JICA Experts on Bengaluru Peripheral Ring Road Project

SUBJECT: Submission of Record of Discussions

Record of Discussion

Number	RD-PRR-DP-005
Objection	Technical Discussion based on Discussion Paper No. R02 & R03
Date	11 th May 2015 15:00~20:30
Venue	Meeting Room in DULT
Attendance	DULT : Mr. Shamanth K, Mr. Sivasubramaniam J BDA : Mr. Srinivask, Mr. H.C Ramendra, Mr. B Nagendra , Mr. Ajithkumar S.M STUP : Mr. T.V.Rajeev , Mr. Srivathsa B K JICA Experts: Mr. T. Tanaka, Mr. N. Kondo, Mr. S. Yamada
Handout	-Discussion Paper R02 (Road : Cross Sections, Vertical Alignment) -Discussion Paper R03 (Road : Junction/Toll Plaza/Rest Area)
Contents	<p>“Overall regarding Land Acquisition”</p> <p>Horizontal alignment will be reviewed based on the technical review by JICA Experts on DP R01 which technically required for fulfilling the design speed of 80km/h to accommodate within available ROW of BPRR. Final Decision will be taken by BDA after the revision in the detailed design.</p> <p>(It has to be confirmed by engineer member)</p> <p>“DISCUSSION PAPER R02 (Road: Cross Sections, Vertical Alignment)”</p> <p>1. Cross Sections</p> <p>1.1 General regarding Cross Sections</p> <p>Typical cross sec

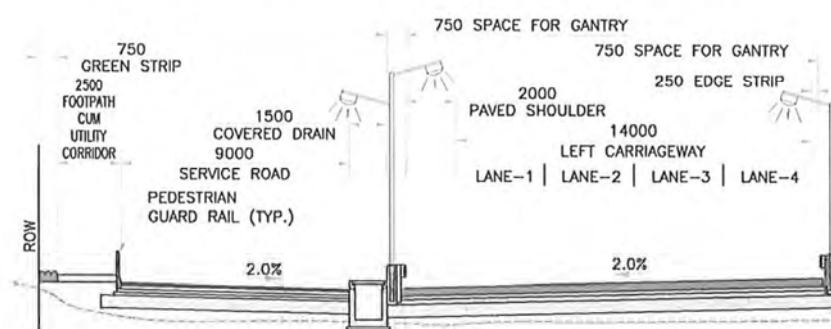
Cross sections on the junction drawings have not been updated. Old sections (without shoulders) are still used in these drawings.

Based on the review by JICA Experts in 2012/13, provision of the shoulders for the mainline was agreed. Figure 1.1 shows the updated cross section in the drawings of "Typical Cross Sections" in Final DPR. Main modifications from Draft DPR are listed below.

Figure 1.2 Old Cross Section in Draft DPR

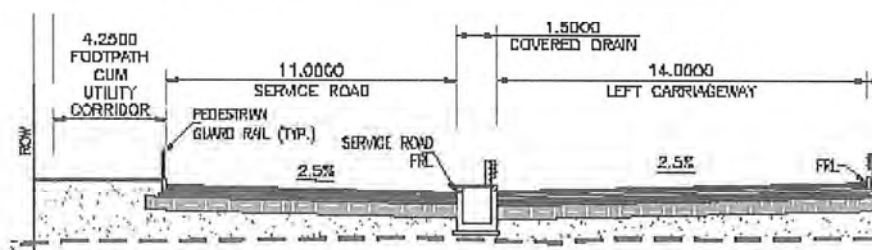
However JICA Experts found the old cross sections (without shoulders) in the drawings of interchanges and junctions.

Figure 1.3 Proposed Concept of Partial Outer Shoulder for BPRR

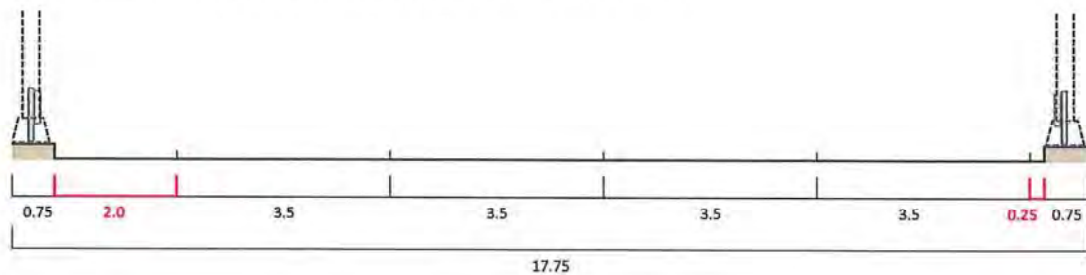
Accordingly, JICA Experts introduces "Partial Shoulder" concept which is well-known in other developed countries' design guidelines (AASHTO, etc) and propose 1.5m width of the outer shoulder for BPRR.

The concept of the proposal of JICA Experts is shown in Figure 1.3. JICA Experts propose 1.5m width of the partial outer shoulder.

Figure 1.4 Cross Sections of Mainline of BPRR (Draft DPR)

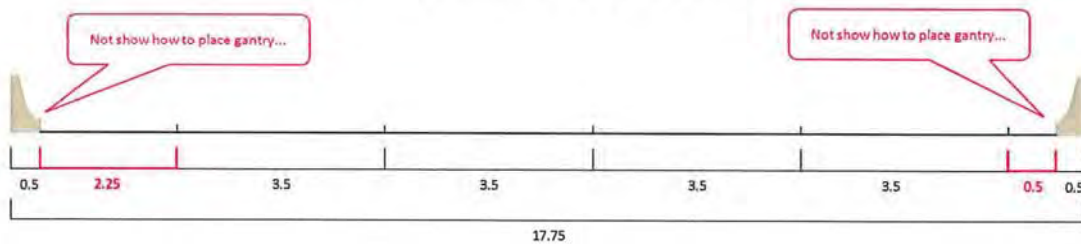
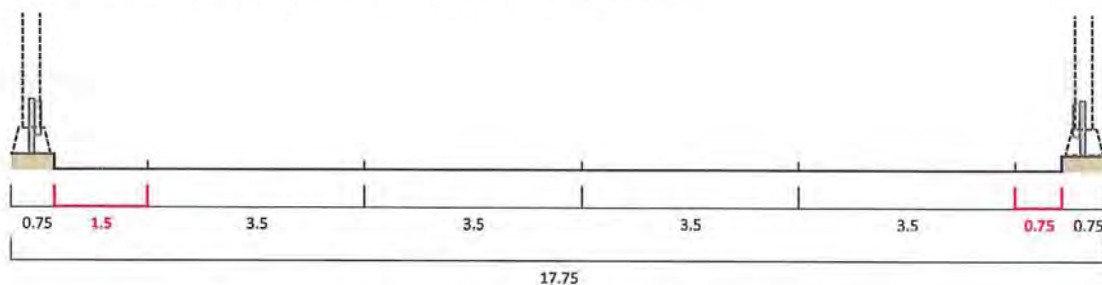
Figure 1.4 shows the cross sections designed in DPR.

Figure 1.5 Cross Sections of Mainline of BPRR (Proposed)

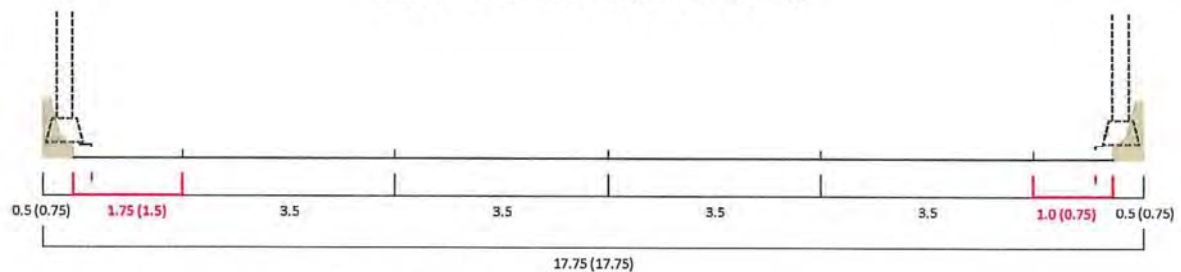
JICA Experts propose the definitive cross sections as shown in Figure 1.5. It is noted that no change has been made to ROW fixed by DPR.

Figure 1.6 Cross Section of Service Road in Final DPR

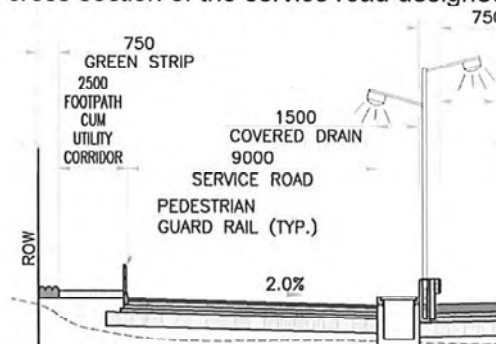
According to IRC-86, 3-lane roads require 10.5m of the carriageway width. Therefore 9.0m of the carriageway width for BPRR can accommodate only 2-lane.

Each direction of the service road can accommodate 2-lane with "partial shoulder" and "edge strip."

Figure 1.7 Cross Sections of Mainline of BPRR (Draft DPR)

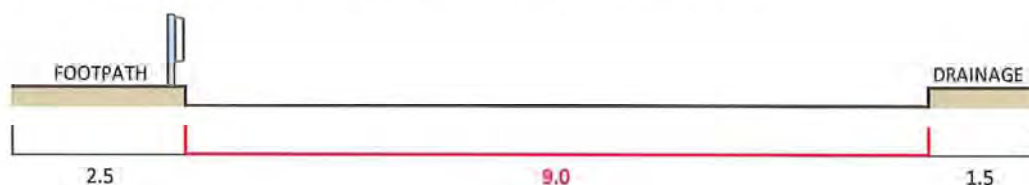
Figure 1.7 shows the cross section of the service road designed in DPR. Lane configuration of the service road is not shown on the drawing.

Figure 1.8 Cross Sections of Mainline of BPRR (Proposed)

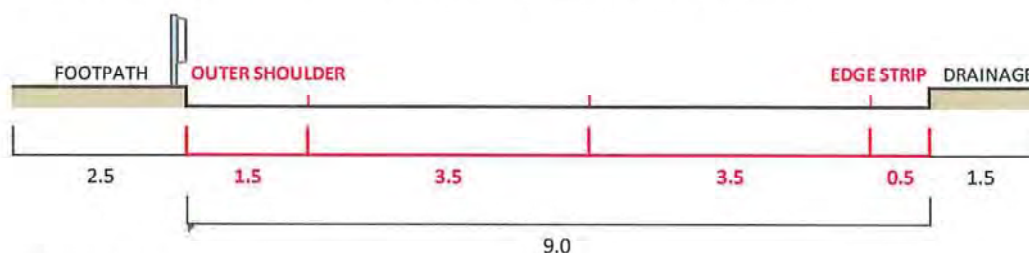
JICA Experts propose the lane configuration as shown in Figure 1.8.

Figure 1.9 Bottleneck of Carriageway

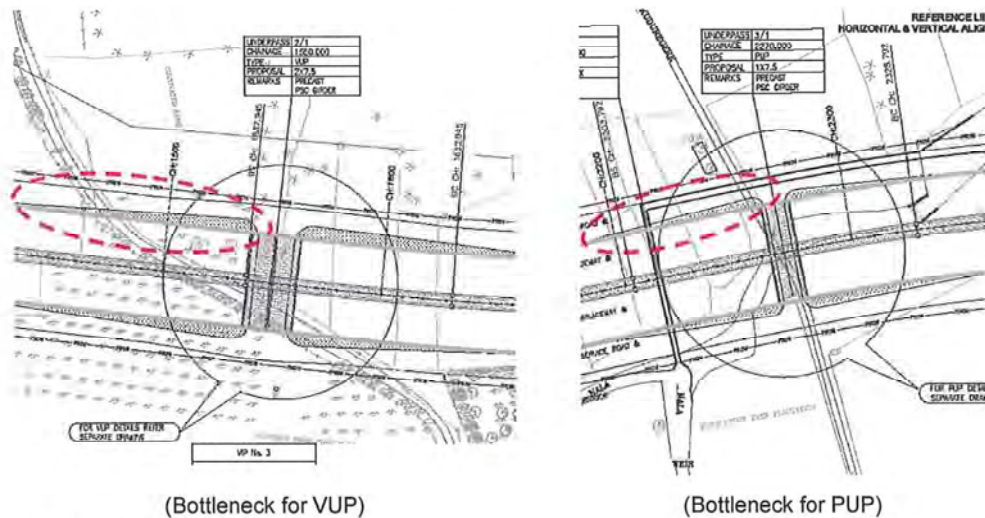
Figure 1.9 shows the narrowed carriageway of the service roads.

Flyovers or bridges shall be studied instead of box-culverts.

Figure 1.10 Vehicle Motion Path at VUP

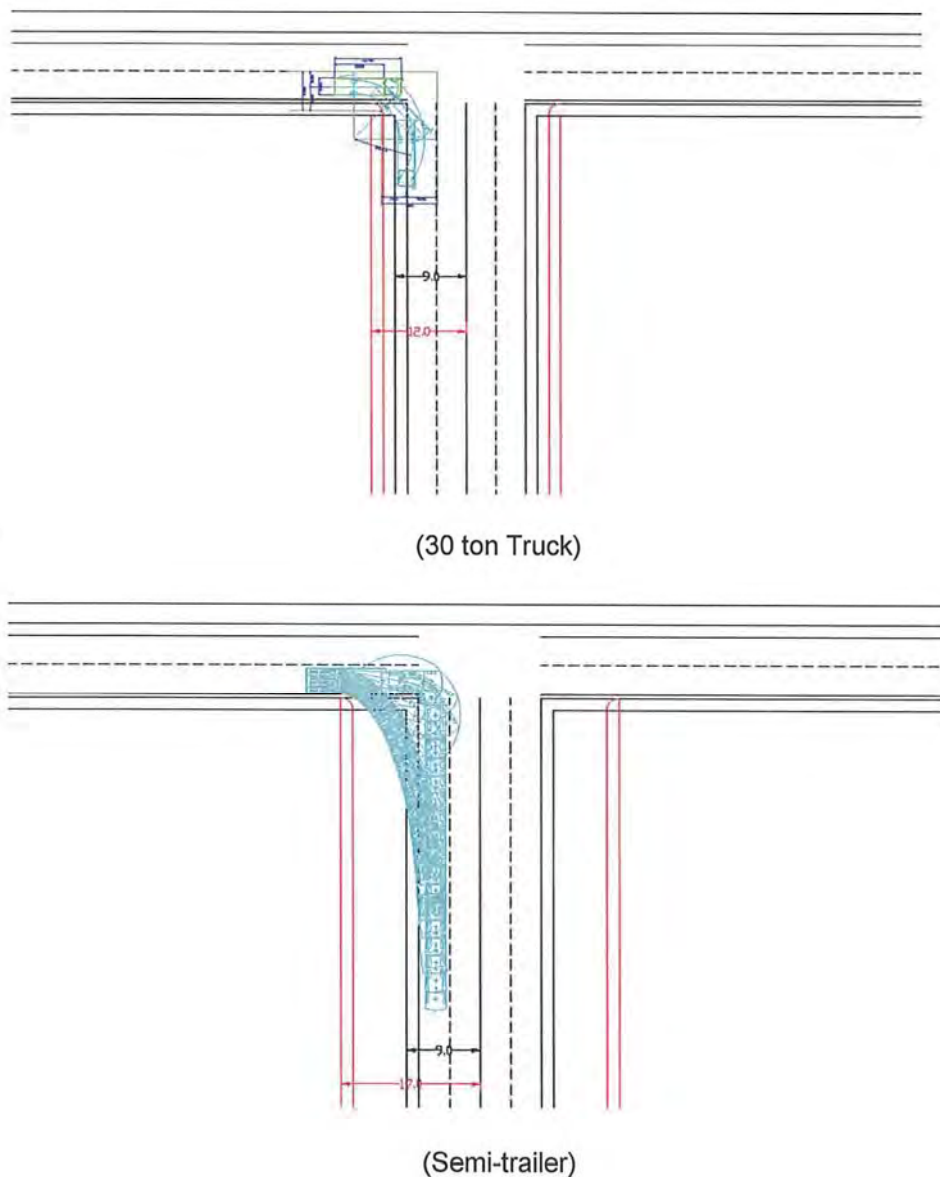
The proposed width of box-culvert cannot manage the traffic flow properly. In order to secure the minimum turning movement of these vehicle, width of the box culvert shall be much larger as suggested in Figure 1.10.

It is quite essential to consider heavy vehicle's turning movement into the design of the VUP.

According to the result of the motion path presented in above figure, size of box-culvert shall be changed to much larger one. JICA Experts recommend flyovers or bridges instead of box culvert for VUP.

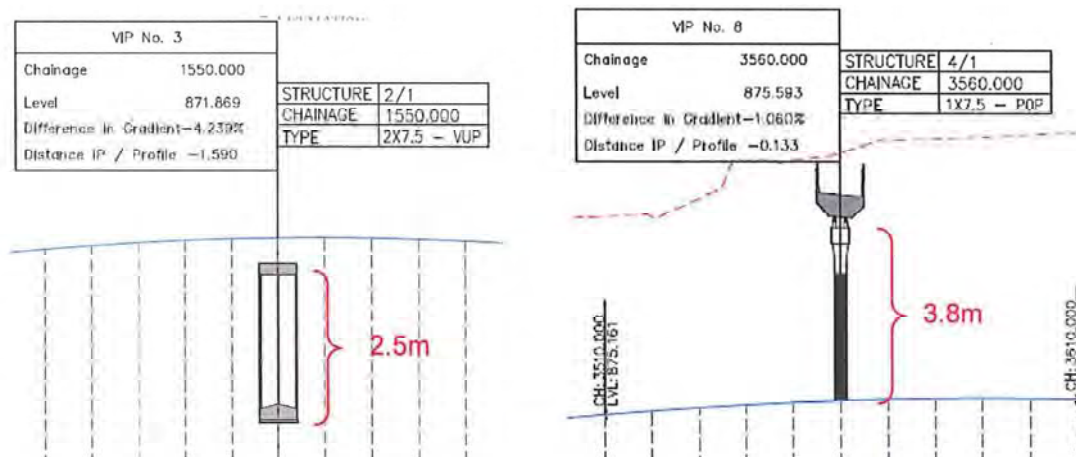
Vertical clearance of 5.5m for vehicular underpasses, 4.5m for pedestrian underpasses

Vertical clearance shall be determined as 5.5 m for vehicular underpasses and 4.5m for pedestrian underpasses in the final DPR. However, several underpasses in the drawing are not kept the clearance as written in final DPR.

(Deformation at MSE Wall of NH-7 in Bangalore)

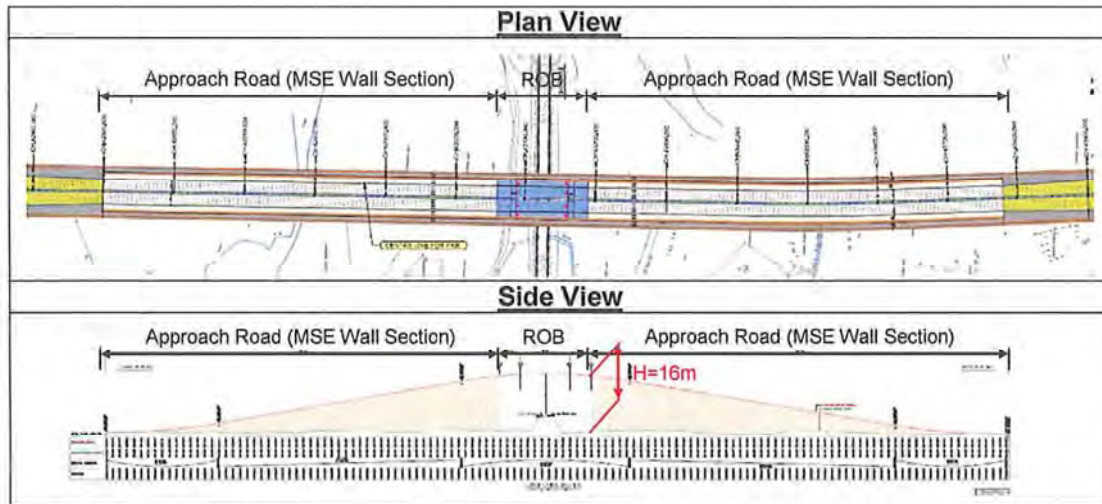
The photo below shows the actual deformation (settlement) of the 6m height MSE wall in Bangalore.

Figure 1.12 Height of MSE Wall at Chennai Railway Line (KM43+100)

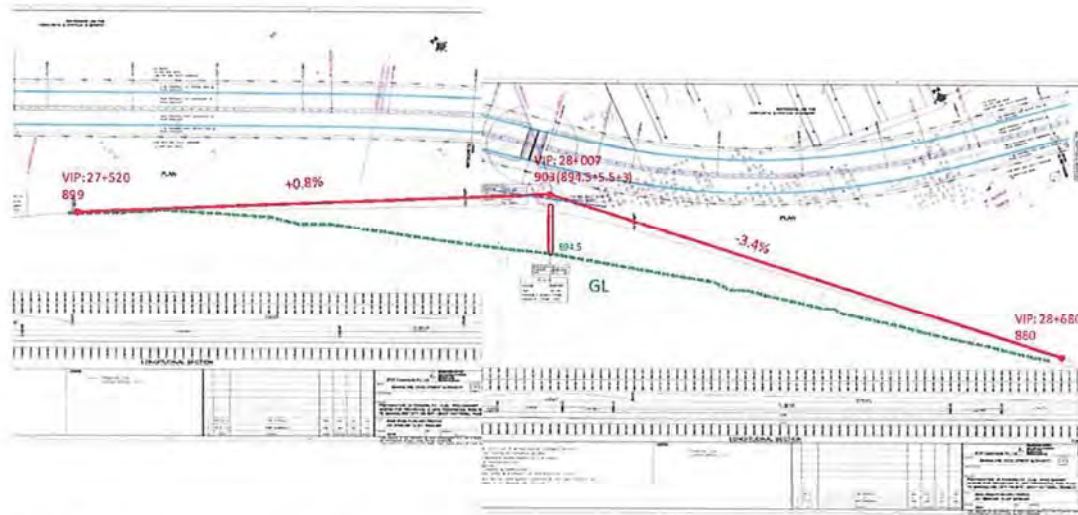
These exceed an experimental standard height (maximum 12m in general); therefore, structural measures or optional structure type are necessary to be considered.

In case of applying tall MSE Wall, following technical measures are necessary to assure structural aspects during design life:

- Considering as critical structure during design life,
- Conducting detail geotechnical investigations at the planned locations,
- Conducting stability/deformation analyses by FEM in static/seismic conditions,
- Conducting consolidation analysis in detail,
- Using specific reinforcing such as metallic/geosynthetic reinforcing, etc.
- Conducting deformation and settlement monitoring during construction and operation periods.

Figure 1.16 Draft Modifications for Vertical Alignment (4)

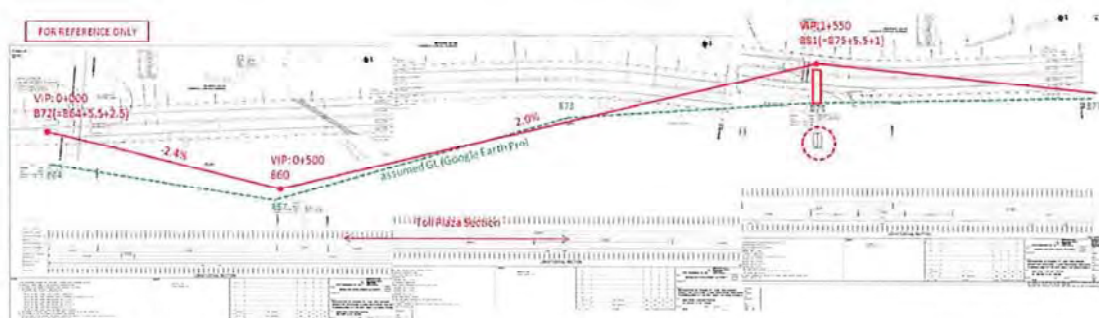
IPC-86 does not specify about the limitation of vertical gradient around toll plaza. Queuing vehicles toward toll booths are sometime stopping on the toll plaza. To avoid minor accident "face to rear hitting" by stopping vehicle due to unintended releasing of brake, the vertical gradient on the toll plaza shall be smaller. Japanese Toll Road Guideline (NEXCO) specifies 2.0% for desirable maximum gradient to avoid the incidents mentioned above.

JICA Experts propose minor modification of the vertical alignment of BPRR as introduced below.

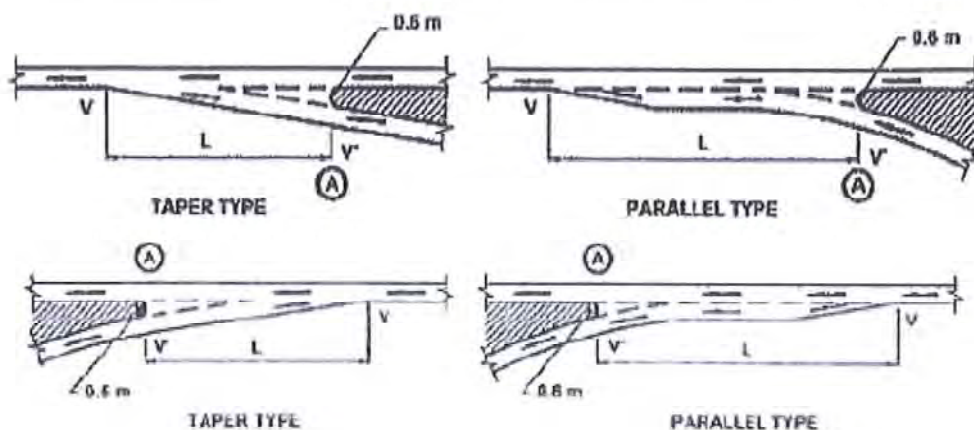
No description on OPR drawings about taper Type and ramp speed

Acceleration lane length shall be 65m and deceleration lane length shall be 80m.

Example of POP (at KM3+600)

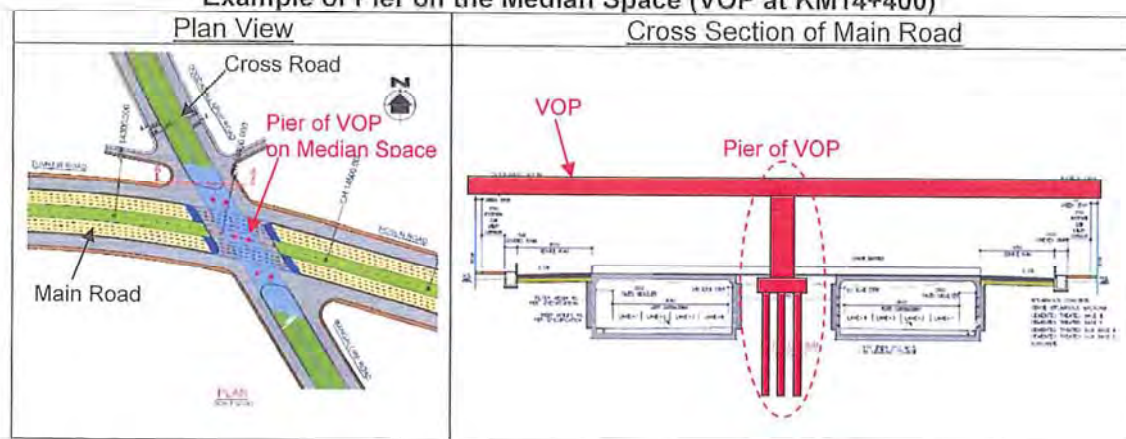
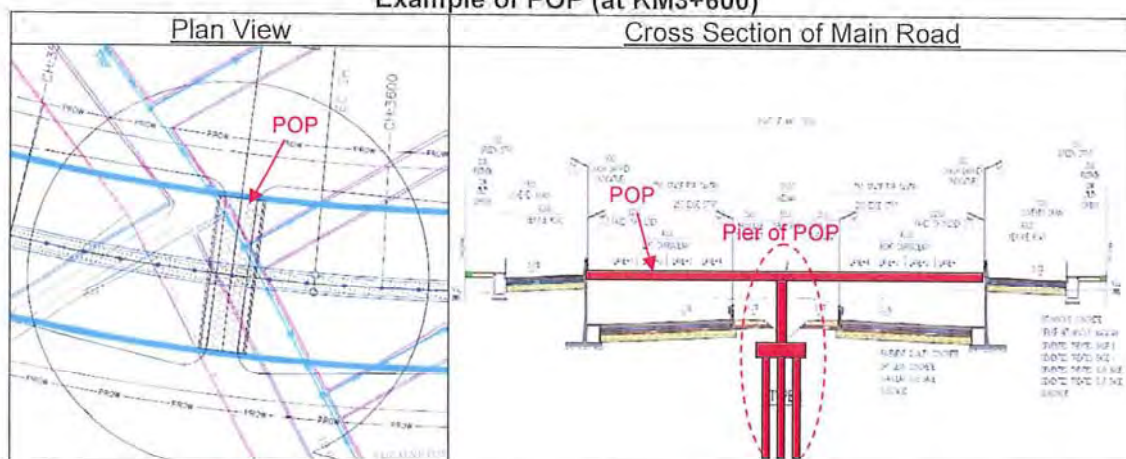
Median of BPRR (w=12m) is planned utilizing to BRT or Metro in the future.

However, piers of VOP are planned on the median space in the Final DPR.

Moreover, it seems that piers of POP are also planned on the median space.

JICA Experts recommend to decide the possibility of pier planning at the median space of main road in consideration of the following aspects.

In case of planning piers on the median space, construction cost may be reasonable by applying shorter span length; however, BRT and Metro should be arranged above VOP in the future.

Vehicle Motion Path at VUP

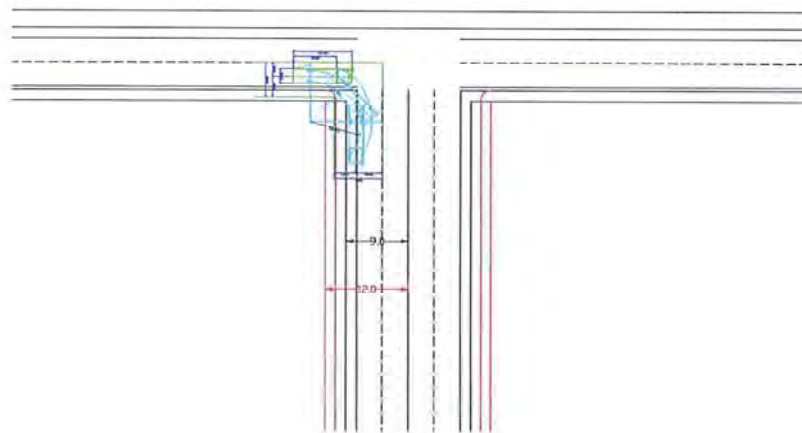
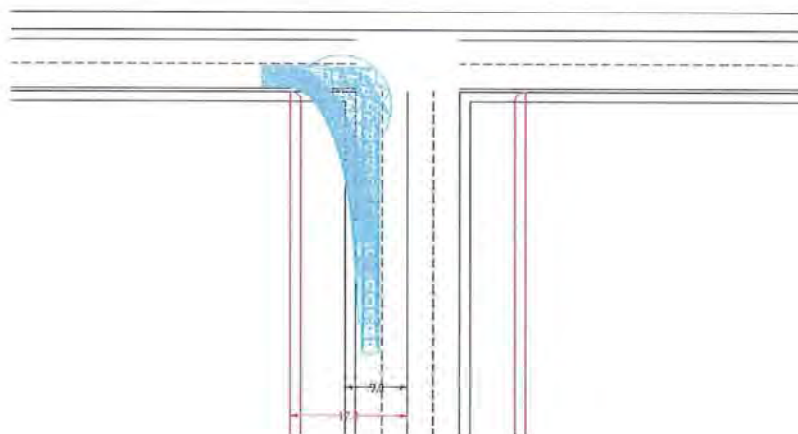
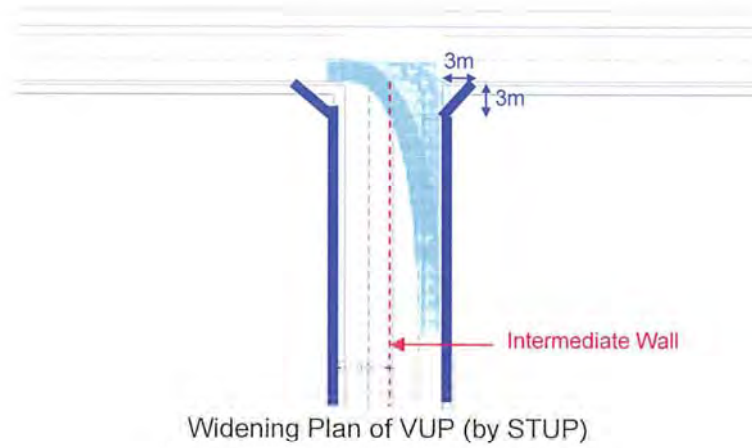
The proposed width of box-culvert cannot manage the traffic flow properly. In order to secure the minimum turning movement of these vehicle, width of the box culvert shall be much larger as suggested in the figure in the next page.

It is quite essential to consider heavy vehicle's turning movement into the design of the VUP.

According to the result of the motion path presented in above figure, size of box-culvert shall be changed to much larger one. JICA Experts recommend flyovers or bridges instead of box culvert for VUP.

Ballary Rd

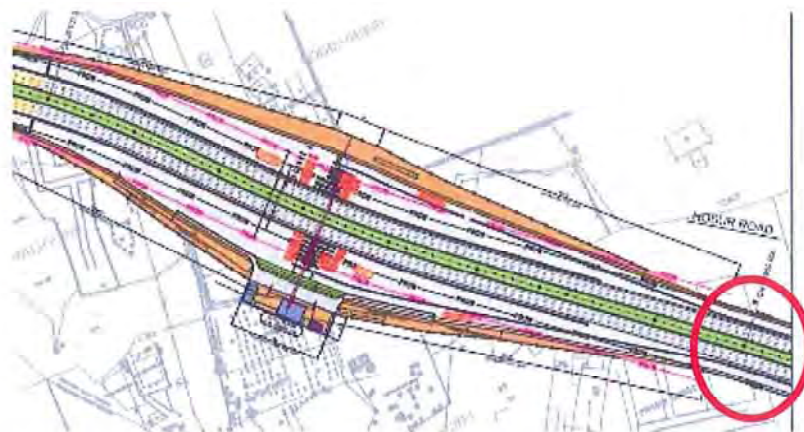
Sharp crest at chainage 17310 which cause poor visibility for car want to exit toward to Hosur.

Hennur JCT

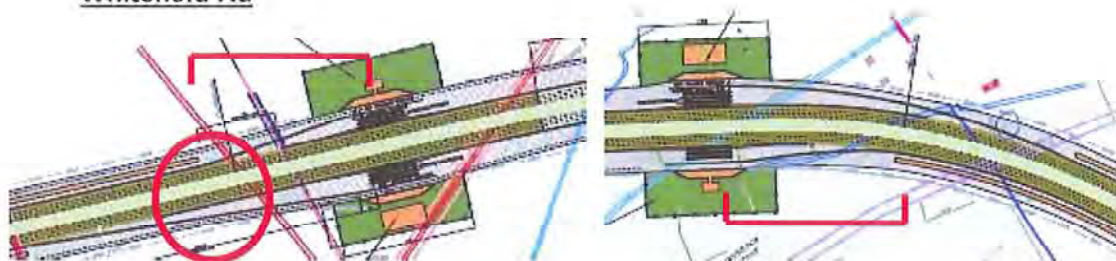
Sharp crest at chainage 26934 which cause poor visibility for car want to entry toward to Hosur and exit toward to Tumkur

Whitefield Rd

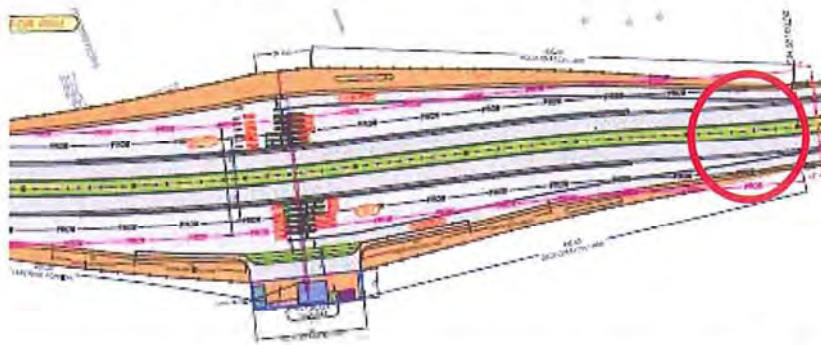
Deceleration length of both exits is too short.
